Memorandum

Date: May 28, 2008
To: Mark Grey, Building Industry Association of Southern California
From: Lisa Austin, Felicia Federico, Aaron Poresky, and Eric Strecker,
Geosyntec Consultants
Subject: Review of Investigation of the Feasibility and Benefits of Low-Impact
Site Design Practices (“LID”) for Ventura County
Geosyntec Project: LA0157

ATTACHMENT 2

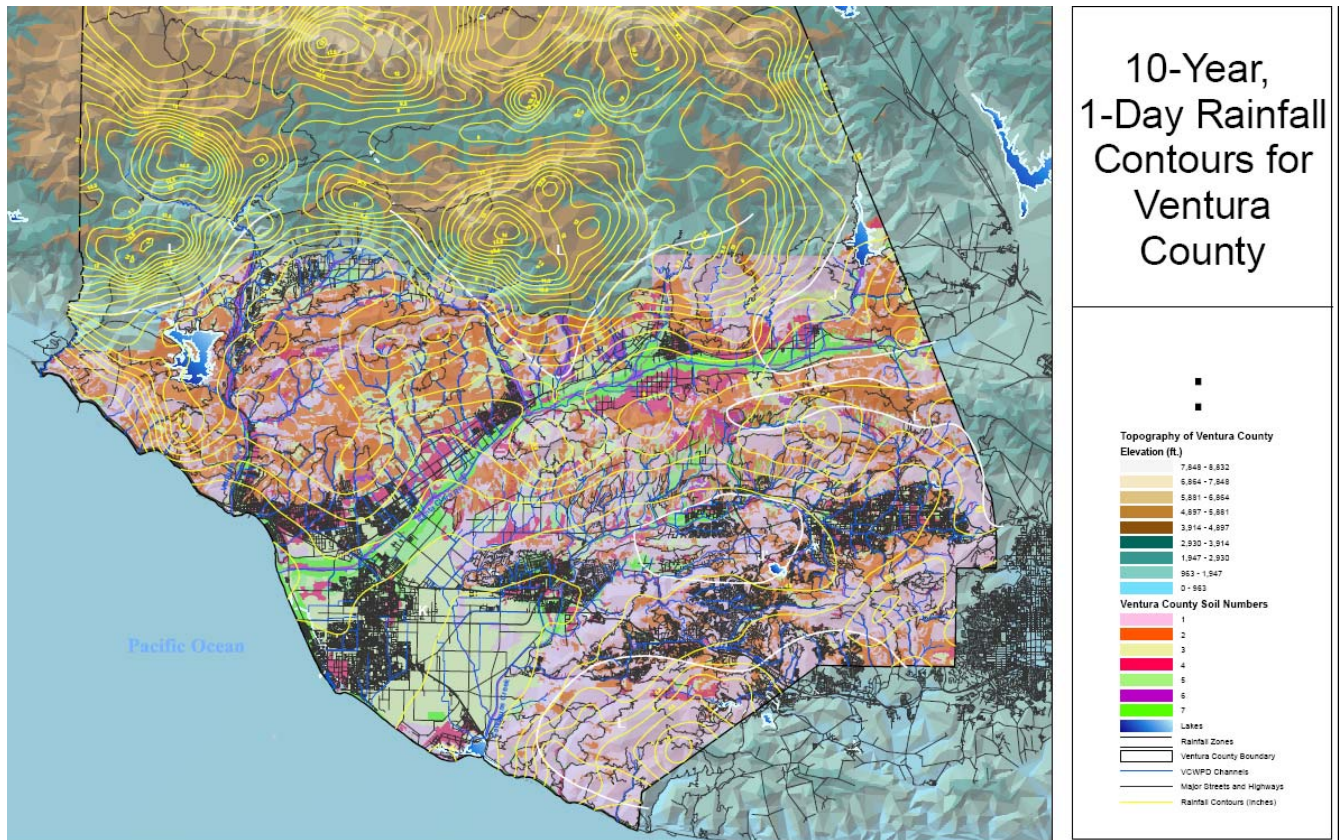
A map that illustrates Ventura County soil types is provided in Attachment 2. Soils have been grouped by the County into seven classifications ranging from a very low infiltration rate (Soil Type 1) to a very high infiltration rate (Soil Type 7). The map in Attachment 2 shows that the soils in the coastal portion of the County (City of Ventura and Oxnard) are predominately Type 3 soils, which have a relatively slow infiltration rate (0.5 inches per hour) when thoroughly wetted, are chiefly soils that have a layer impeding downward movement of water, or are moderately fine textured soils that have a slow infiltration rate when dry. The eastern portion of the County (Thousand Oaks, Simi Valley, and Moorpark) appear to have predominately Type 1 soils, which are soils with a very low infiltration rate (0.25 inches per hour) when wetted. They are chiefly clays that have a high shrink-swell potential, soils that have a high permanent water table, soils that have a claypan clay layer at or near the surface, or soils that are shallow over nearly impervious material. Type 1 soils will have very, very low infiltration rates when compacted. By comparison, the Chralowicz study analyzed scenarios with infiltration rates between 0.5 and 2.0 inches per hour.

- The Chralowicz study, which was used as the primary basis for estimating infiltration capacity, is based on assumptions that are not necessarily representative of typical conditions in Ventura County. Assumed infiltration rates are notably higher than typical Ventura County soils. Rainfall patterns are within the range of Ventura County conditions, but notably lower than some parts of Ventura County. Assumed infiltration basin design standards are not representative of typical LID features.
